PLANNING COMMISSION MEETING AGENDA REGULAR MEETING

January 25, 2022

SUBJECT: PRELIMINARY SITE PLAN REVIEW (SP JPLN2021-016) - Proposed The Westington II, South of Wattles, East of Crooks (870 Barilane Drive; PIN 88-20-21-101-009), Section 21, Currently Zoned NN (Neighborhood Node "I") District

Preliminary Site Plan Review For City of Troy, Michigan

1 Landscape Plan
SCALE: 1" = 30'

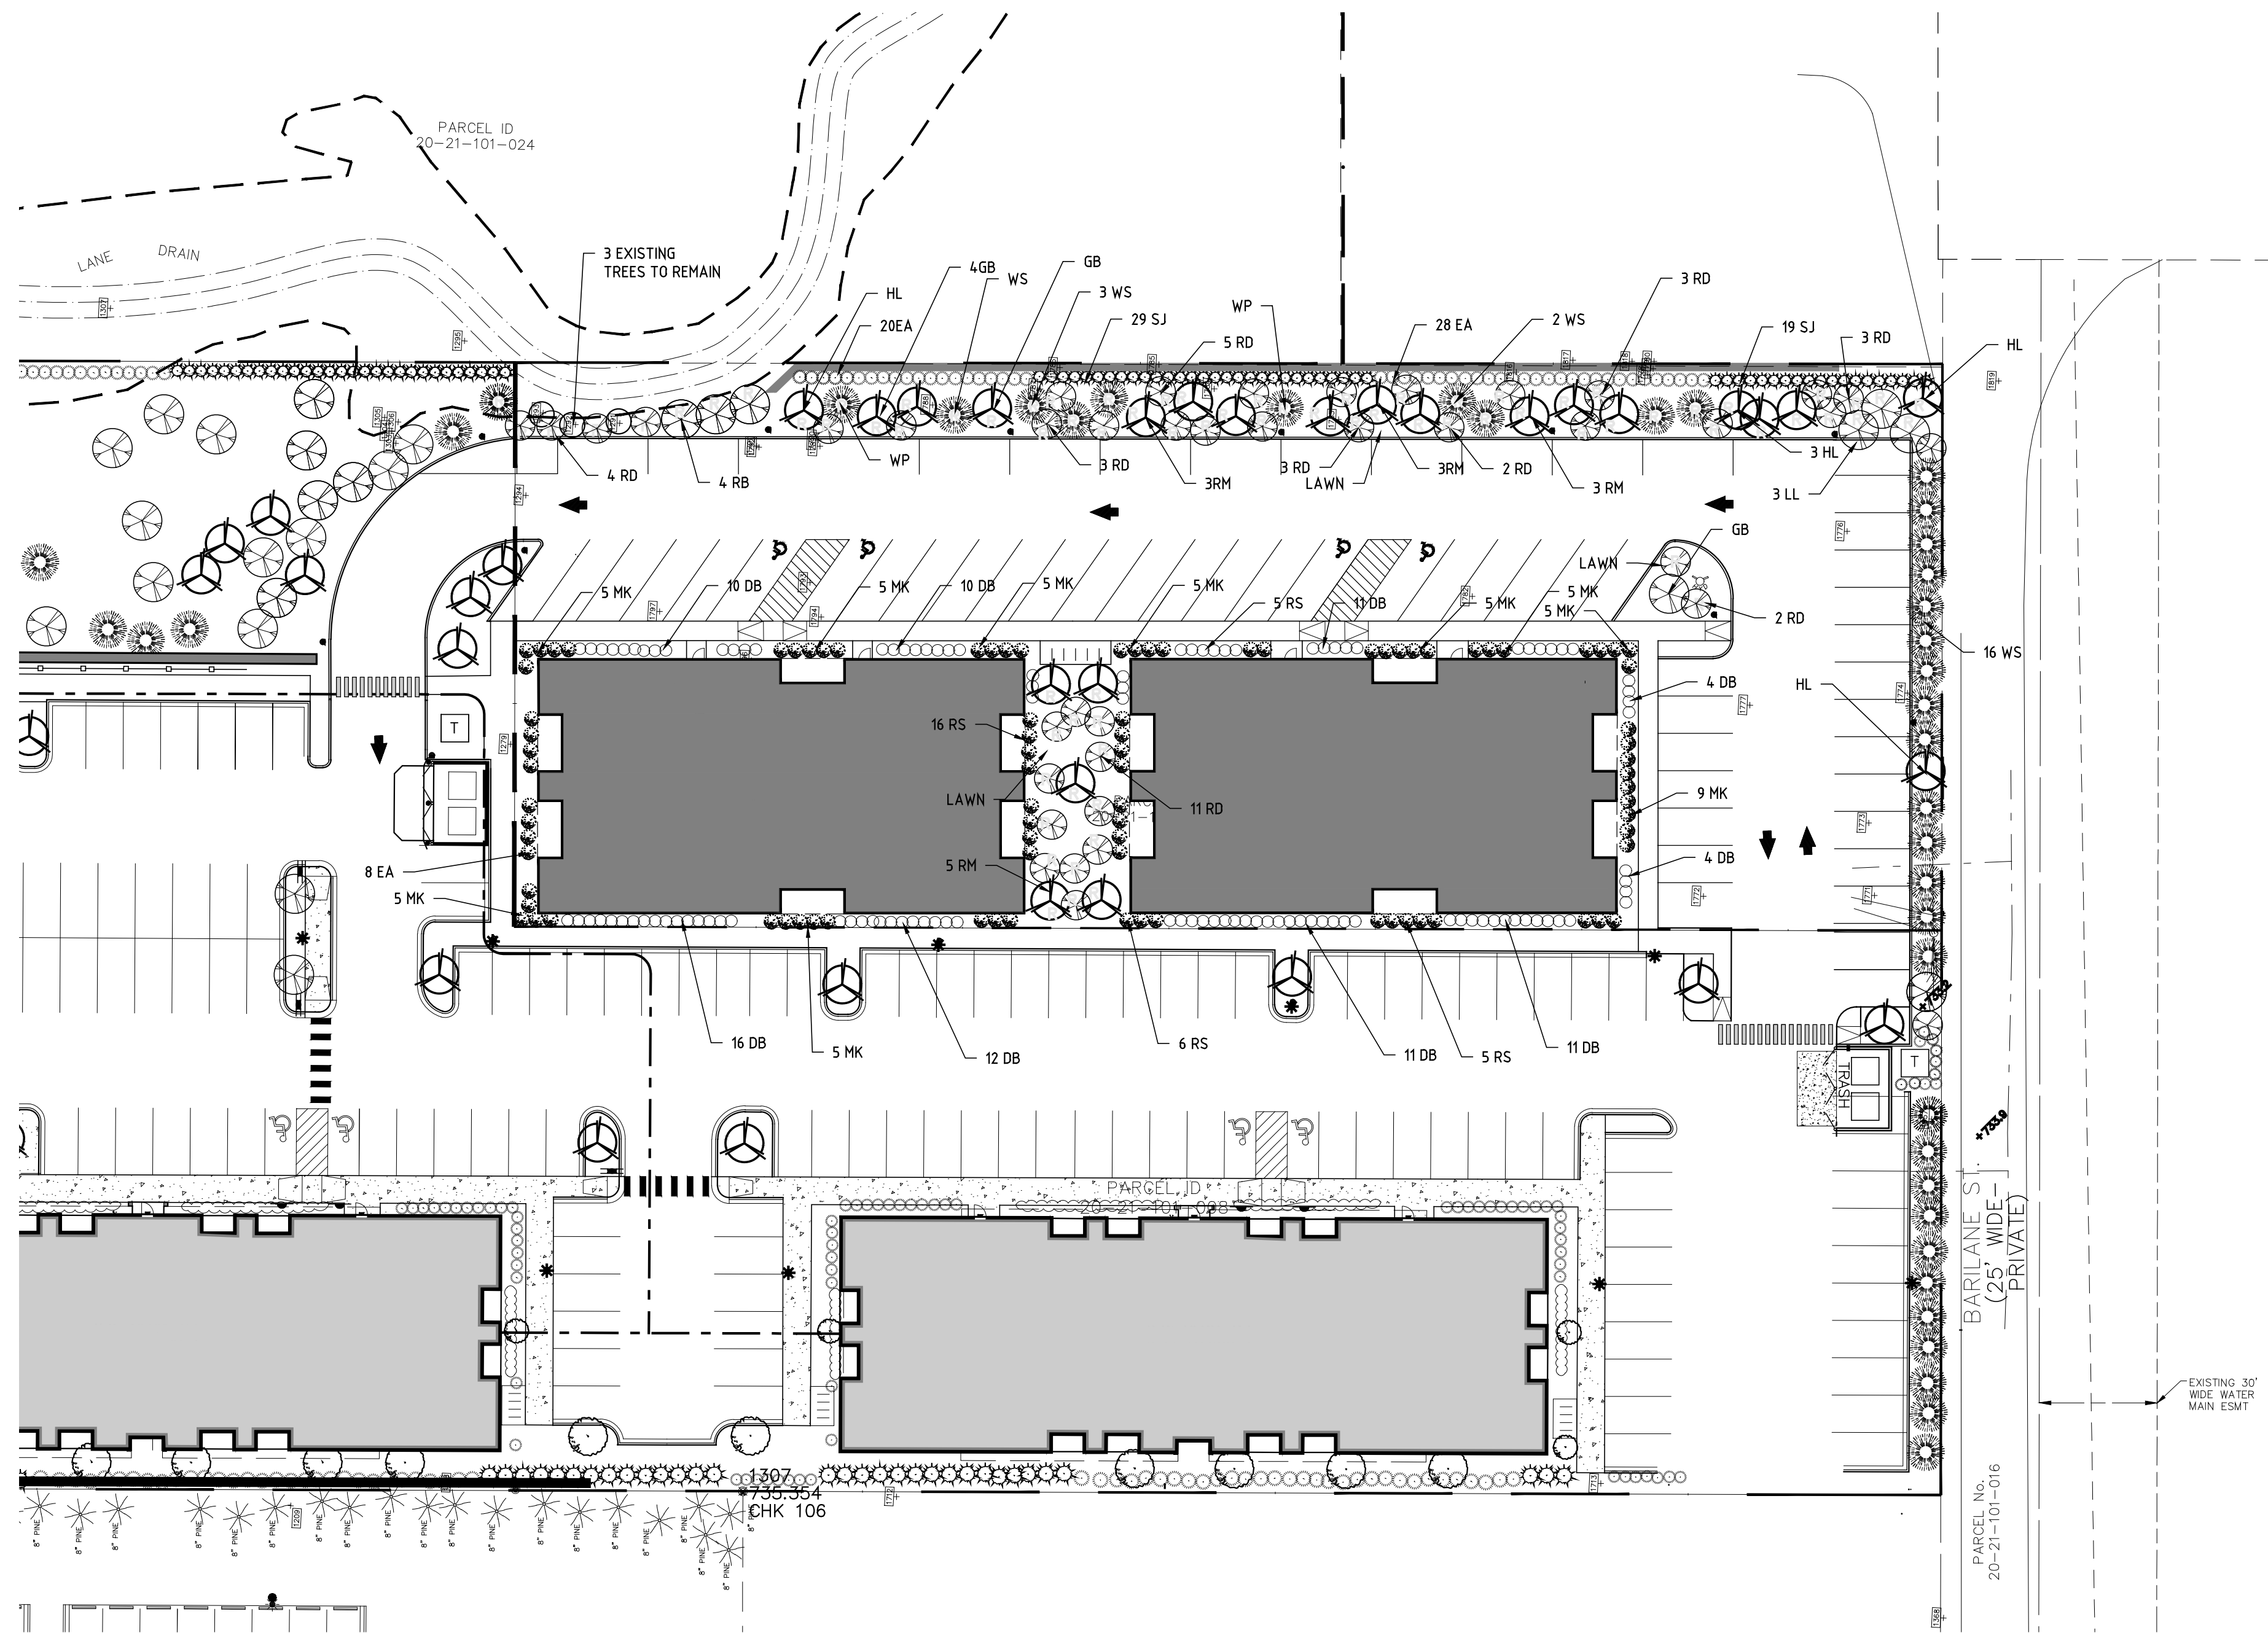
A landscaping plan has been provided on Sheet L101. The following table discusses the development’s compliance with the landscape requirements set forth in Section 13.02.

Required:	Provided:	Compliance:
East Property Line:			
<u>Landscape buffering:</u> Required buffering between two differentiating land uses. Alternative 1 or 2.	1 large evergreen every 10 feet or 1 narrow evergreen every 3 feet. Alternative screening method may be considered by the Planning Commission.	1 narrow evergreen every 3 feet.	Complies
<u>Southeast property line: (adjacent to existing single-family home)</u>			
<u>Landscape buffering:</u> Required buffering between two differentiating land uses. Alternative 1 or 2.	1 large evergreen every 10 feet or 1 narrow evergreen every 3 feet. Alternative screening method may be considered by the Planning Commission.	1 narrow evergreen every 3 feet along northern property line.	Complies
West Property Line:			
<u>Landscape buffering:</u> None required	None required	A variety of trees and bushes, numbering approx. 164 plants.	Complies
South Property Line

Floor Plans

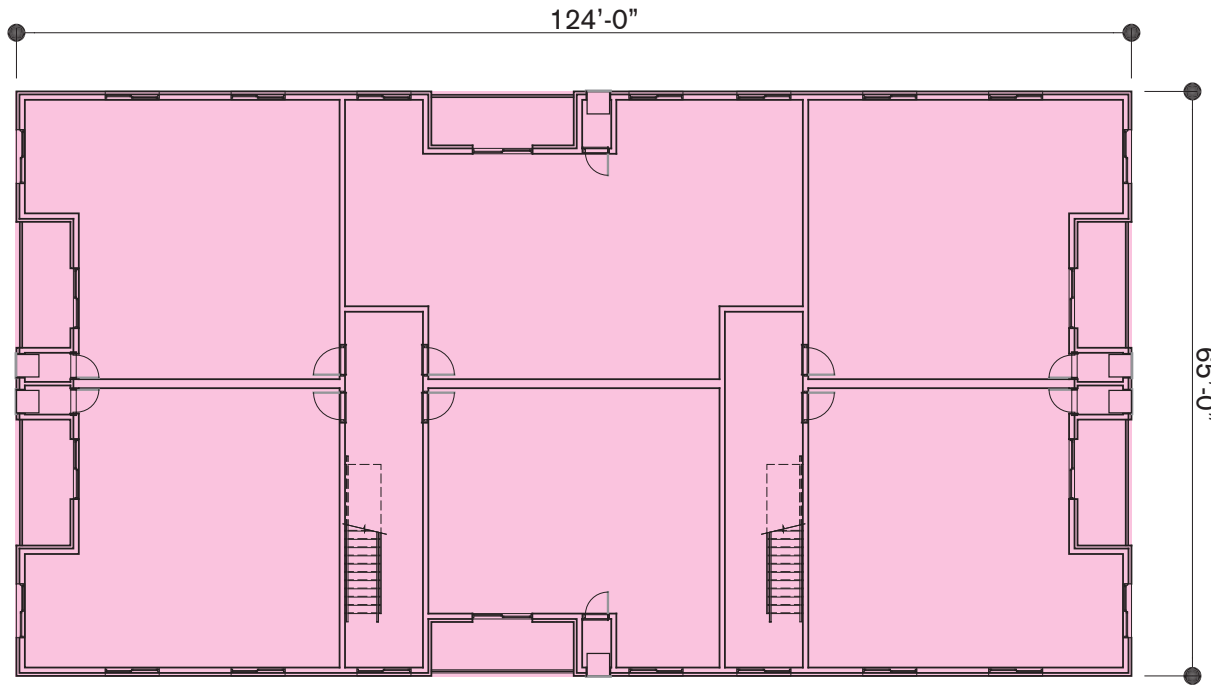
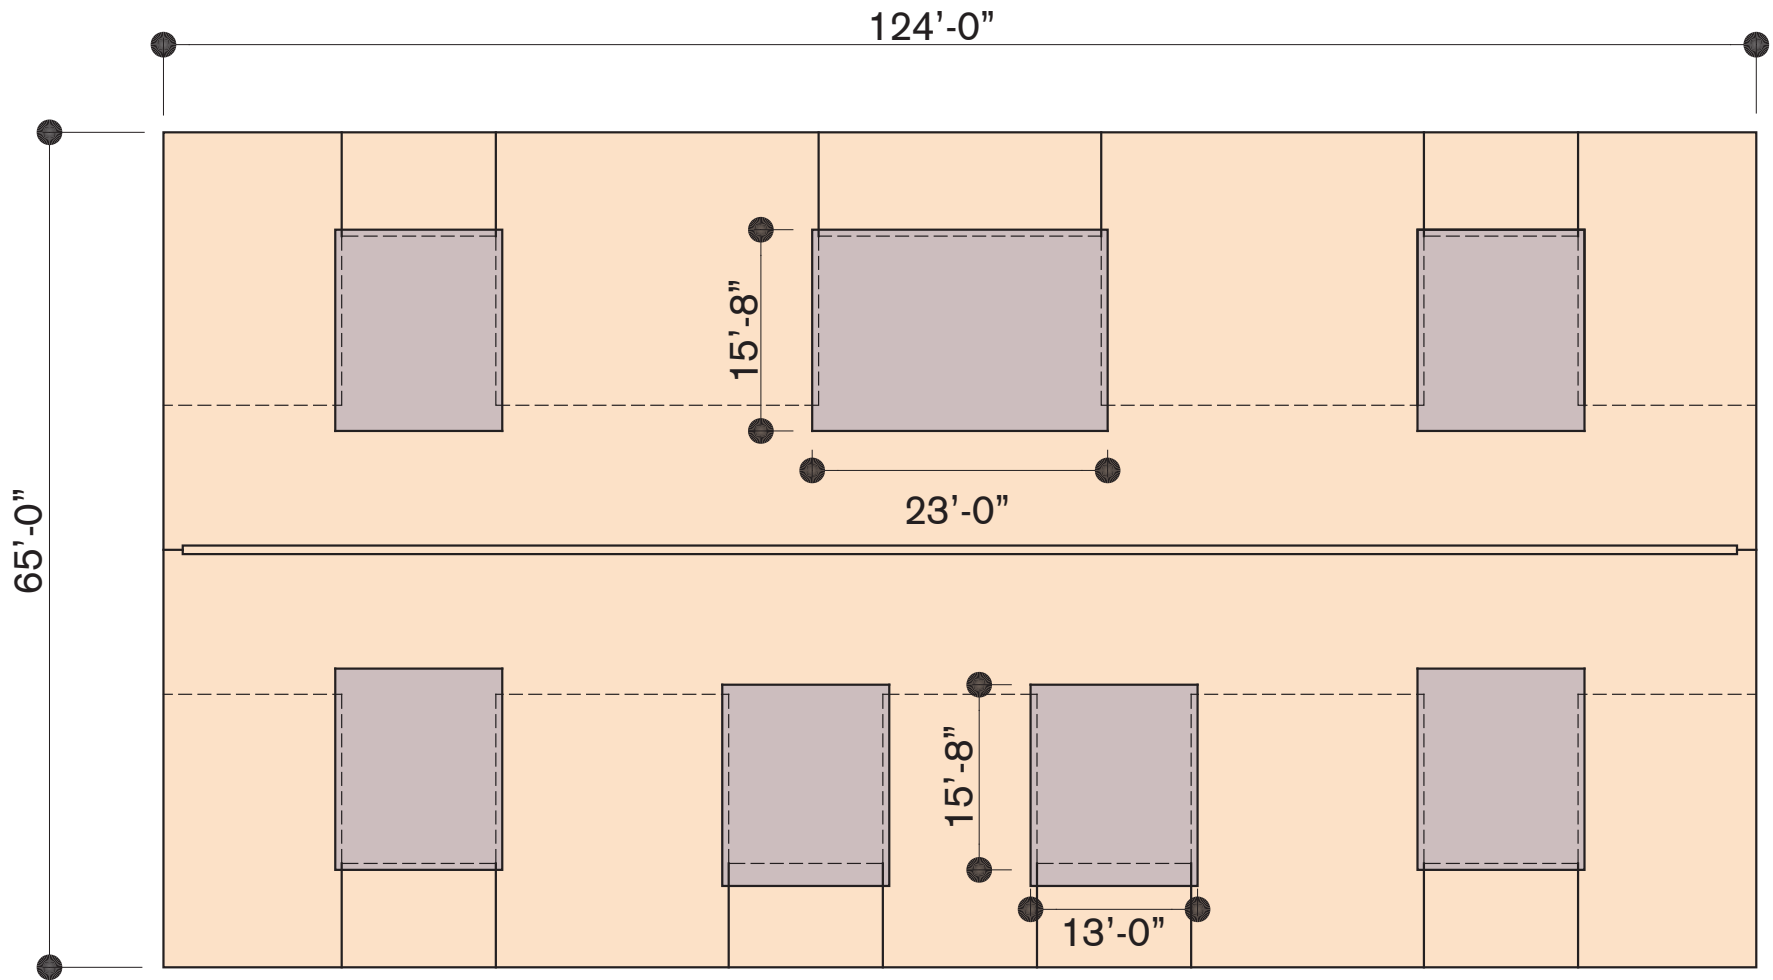
During the review process, we had asked the applicant to confirm that the building complied with the 2.5 story maximum. The applicant’s architect provided additional plans and the required calculations. The City’s Building Official reviewed the plans and the calculations and confirmed that the building meets the 2.5 story requirement as defined in the Zoning Ordinance. The applicant’s architect plans and calculations, and the Building Official’s response are provided in your packet.

1 Landscape Plan
SCALE: 1" = 30'

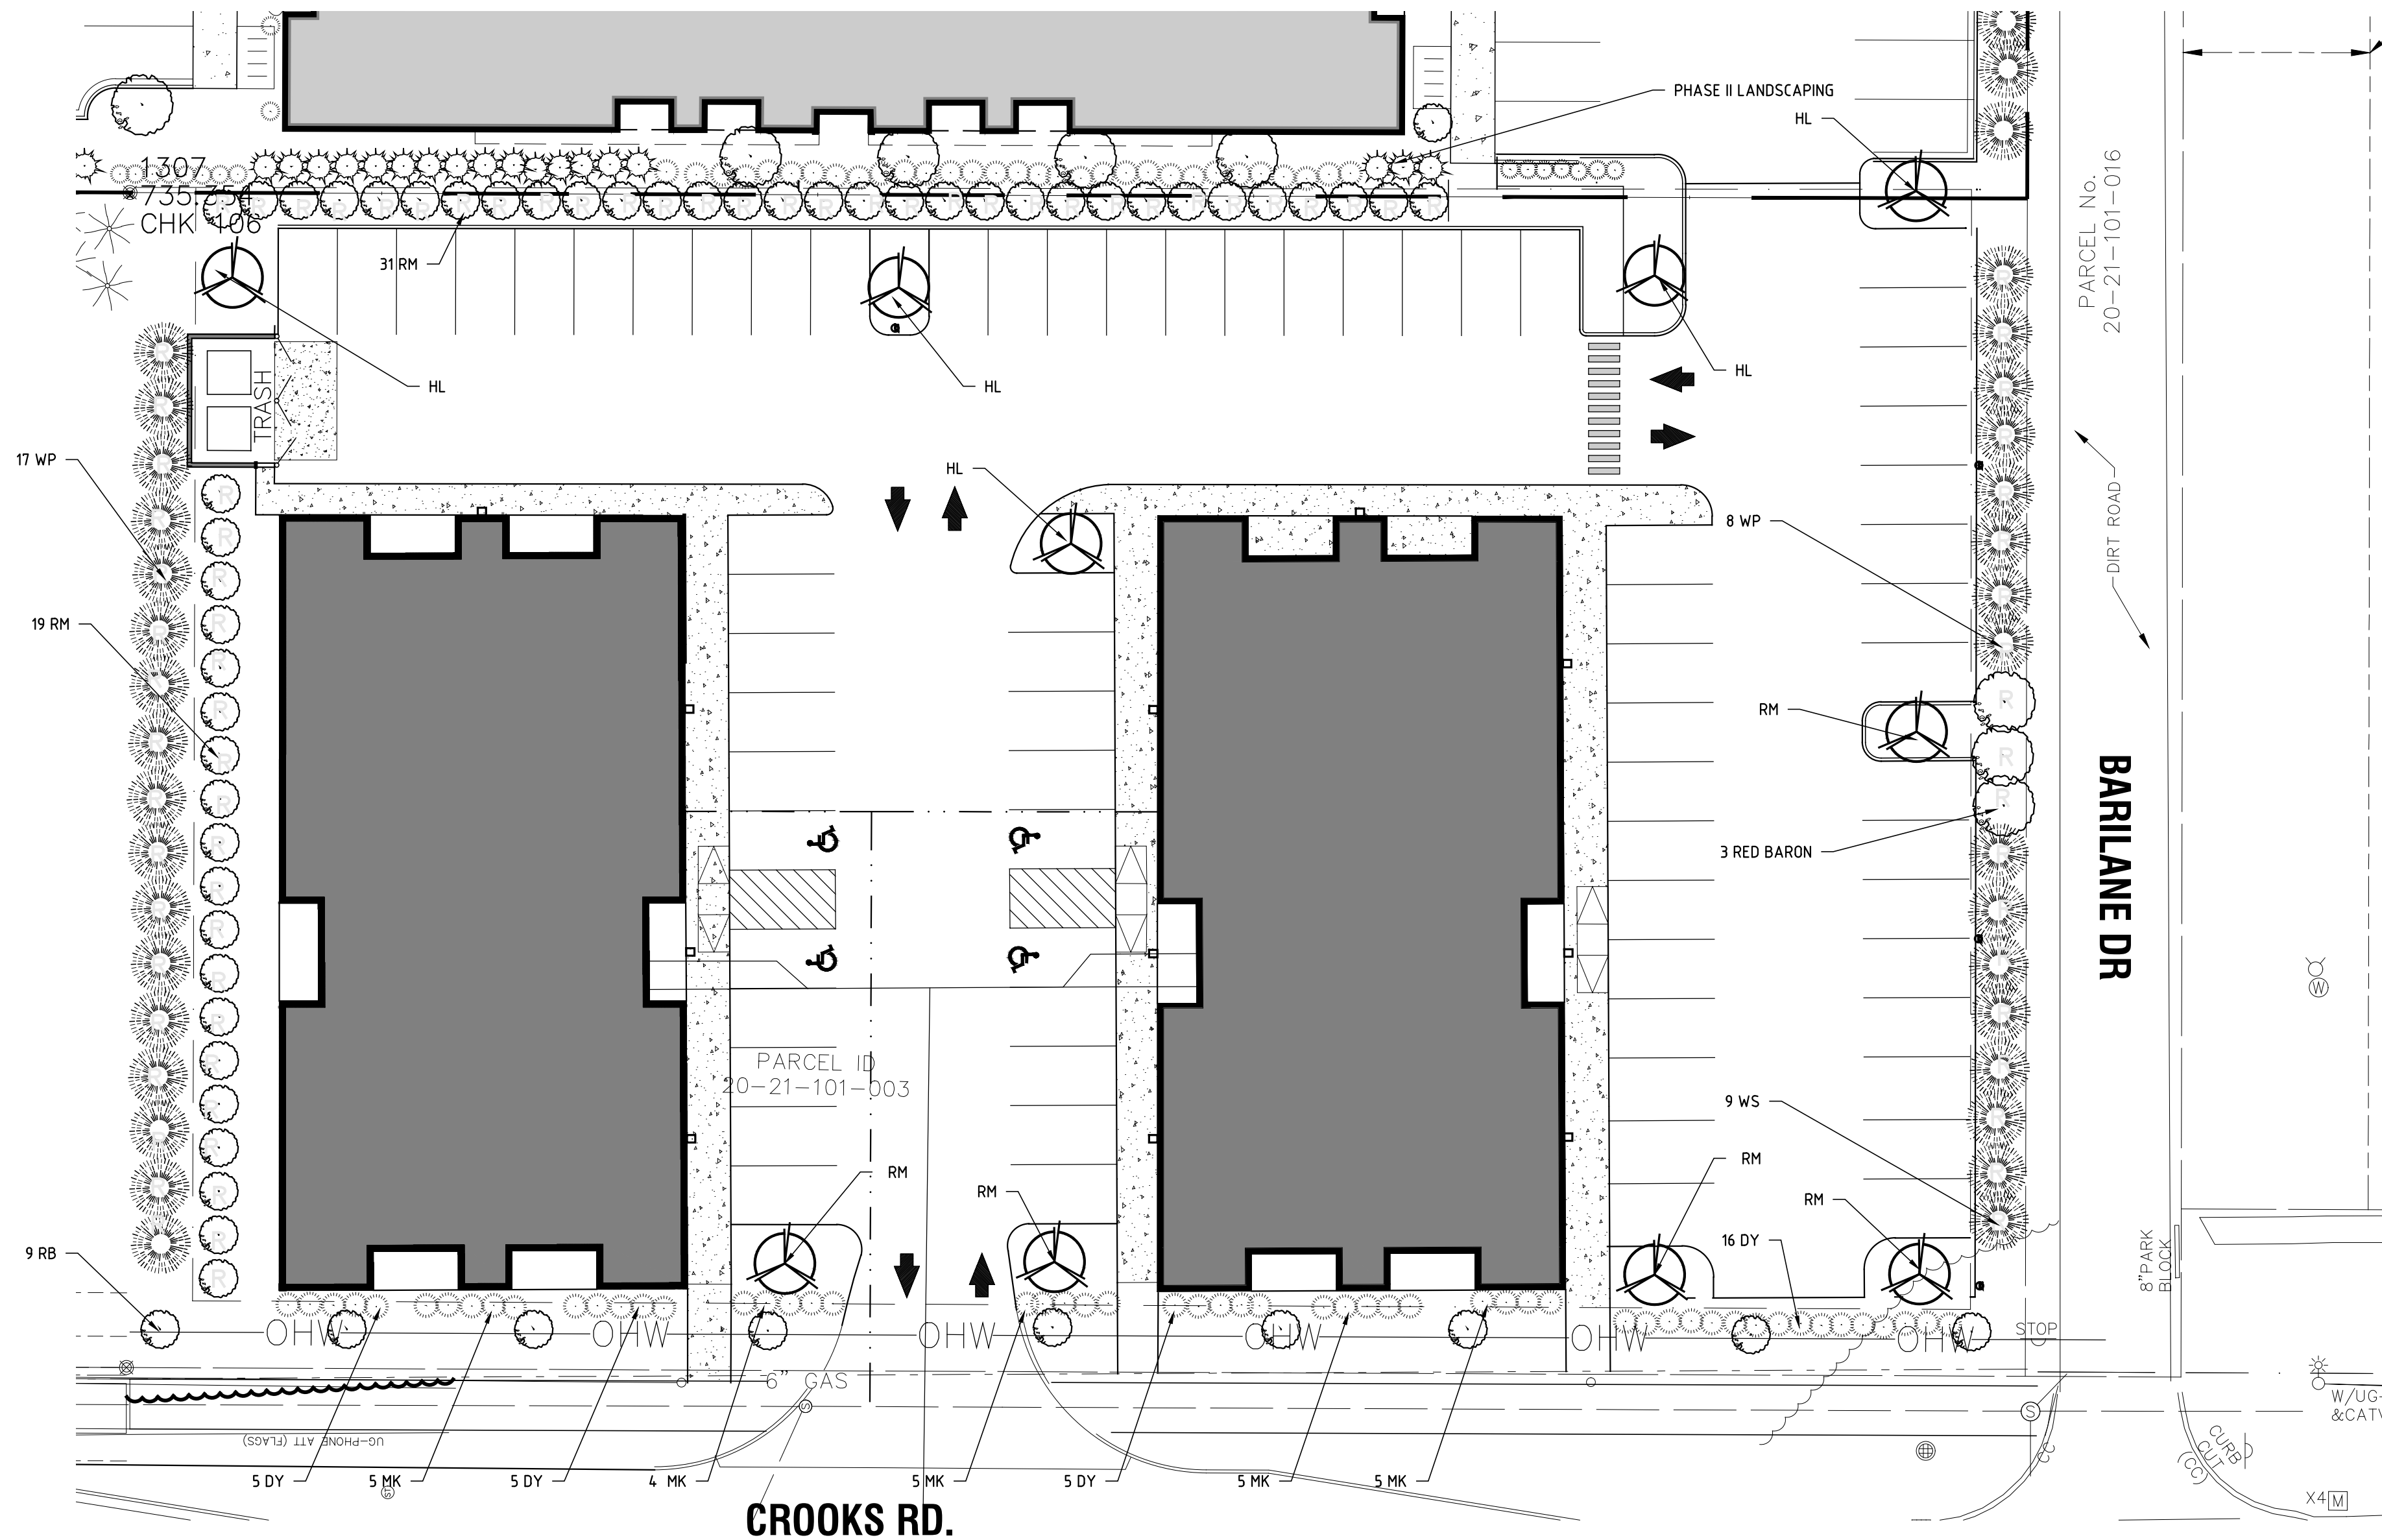
Woodlands: A tree inventory and replacement plan has been provided on Sheet L100, with replacement trees shown in the landscape plan on Sheet L101. The applicant notes that a total of 230 inches will be removed, requiring 115 inches of replacement.

Items to be addressed: *Is the applicant able to shift the site to preserve additional trees?*
